Subject: Grand Gulf Nuclear Station
Docket No. 50-416
License No. NPF-29
GGNS Pilot Full-Scope Application of NUREG-1465 Alternative Source
Term Insights, Additional Information, Supporting LDC 2000-070

GNRO-2000/00100

Suppression Pool pH and Iodine Re-Evolution Methodology

ENTERGY OPERATIONS
Engineering Report
For
SUPPRESSION POOL PH
AND IODINE RE-EVOLUTION
METHODOLOGY

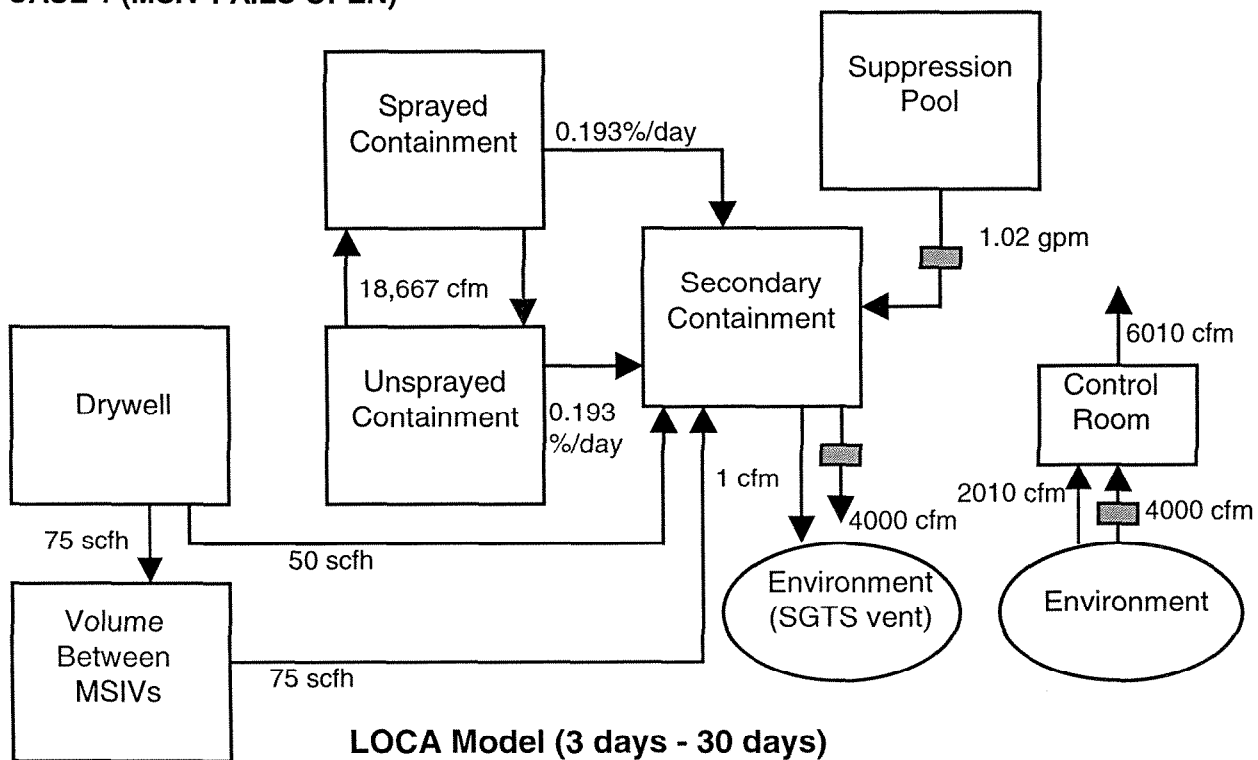
Question 3:

The GGNS LOCA dose calculation did not assume 2010 cfm of unfiltered in-leakage into the control room for the duration of the accident. Specifically, after 3 days, the in-leakage was reduced to 10 cfm. What is the impact on the control room dose if the 2010 cfm were assumed to continue after 3 days for the entire duration of the accident?

Response:
